M54 to M6 Link Road

**8.8 P(A) Draft Statement of Common
Ground with Environment Agency**

Regulation Number	Regulation 5(2)(q)
Planning Inspectorate Scheme Reference	TR010054
Application Document Reference	8.8 P(A)
Author	M54 to M6 Link Road Project Team and Highways England

Version	Date	Status of Version
3 (P05)	3 November 2020	Issue to the ExA for Deadline 1

Drawing Title
**FIGURE 1:
 PROPOSED WATERCOURSES**

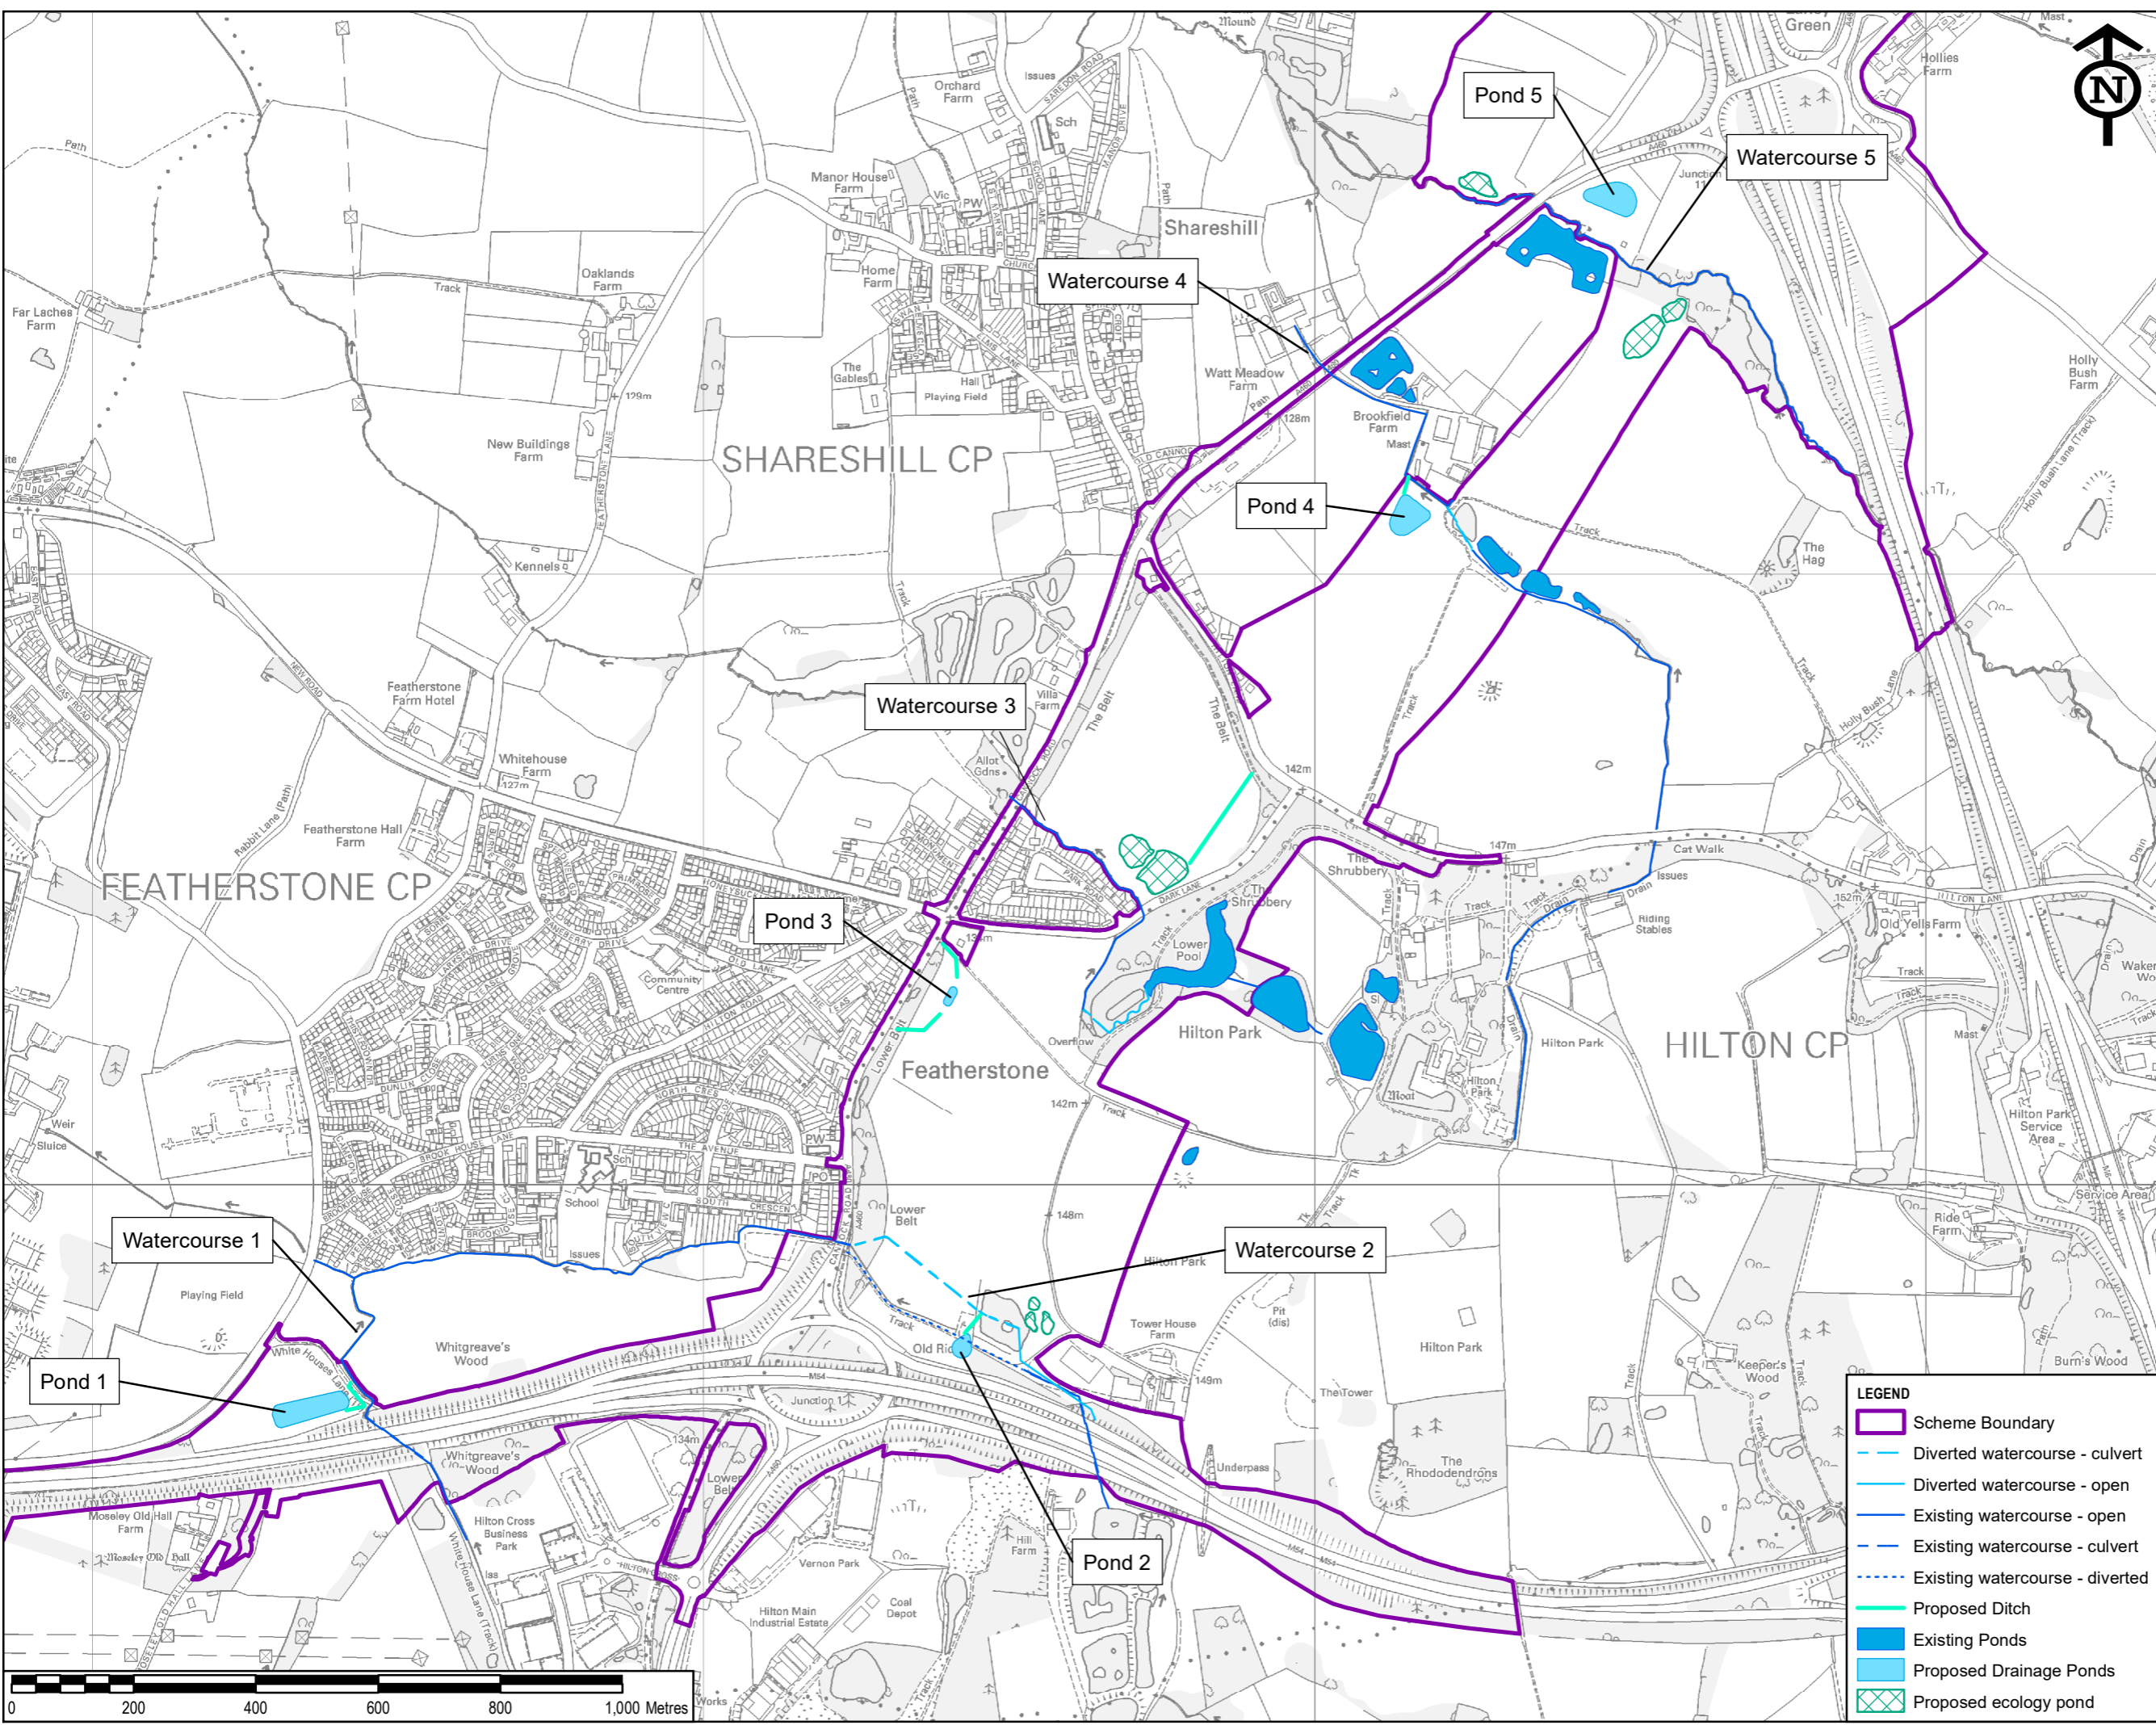
ES Chapter	Paragraph Reference	Sub-section	Environment Agency Comment	Highways England Response	Status	Agreement likely?	
						APP? ¹	IP?
				025/6.1], or Appendix 13.4: WFD Assessment [APP-203/6.3].			
Appendix 13.4 Water Framework Directive of the ES [APP-203/ 6.3]	-	Impact on improvements to Saredon Brook.	<p>The Environment Agency believe that the scheme will have an impact on mitigations measures identified by the Environment Agency to improve Saredon Brook under WFD. This is because the culverted watercourse would impact on the measures including:</p> <ul style="list-style-type: none"> • retain marginal aquatic and riparian habitats (channel alteration) • preserve and where possible enhance ecological value of marginal aquatic habitat, banks and riparian zone • preserve and, where possible, restore historic aquatic habitats, and • increase in-channel morphological diversity 	<p>Watercourses 3-5 as shown on Figure 13.1B [AS-029/6.2] of the ES are within the Saredon Brook WFD water body catchment. Paragraph 6.2.5 of Appendix 13.4 WFD Assessment [APP-203/6.3] states “It is acknowledged that the culverts proposed for Watercourse 3 and Watercourse 4, and the outfalls to Watercourse 5 (Latherford Brook) are potentially inconsistent with the above mitigation measures proposed by the Environment Agency to improve the status of some WFD parameters of this water body. However, the physical impact of these structures would be very localised in nature and affecting the first order and minor channels of headwater tributaries, rather than the main stem of the water body. The impact would also be compensated by the creation of new ditchcourses as part of the highway drainage system, but designed to best practice and linking existing green corridors with proposed treatment and attenuation ponds along the Scheme.” In addition, and not explicitly mentioned in Appendix 13.4 WFD Assessment [APP-203/6.3], the Scheme will also extend the channel of Watercourse 3 where the</p>	Under discussion	High

ES Chapter	Paragraph Reference	Sub-section	Environment Agency Comment	Highways England Response	Status	Agreement likely?	
						APP? ¹	IP?
				<p>impoundment for Lower Pool is relocated (refer to Figure 1 appended to this SoCG) which provides further compensation for the proposed 55 m culvert. Highways England are not aware of any specific Environment Agency led initiatives to implement these mitigation measures within the Scheme boundary, but where possible the views of the Environment Agency could be taken into account where new ditchcourses or other channels are being created by the Scheme. The overall effect of the Scheme is to provide a net gain in new watercourse channel within the Saredon Brook Catchment. In total 241 m of new channel will be provided as shown in the Table 2, Appendix B of this SoCG. As a result, it is predicted and reported in Appendix 13.4 WFD Assessment [APP-203/6.3] that the Scheme will not prevent improvement of the Saredon Brook from Source to River Penk (GB104028042571) WFD water body. Please refer to commitments D-WAT2-6 and D-BIO1 in Table 3.4 of the OEMP for details of the mitigation proposed with regards to the design of culverts, ditchcourses from treatment ponds, and</p>
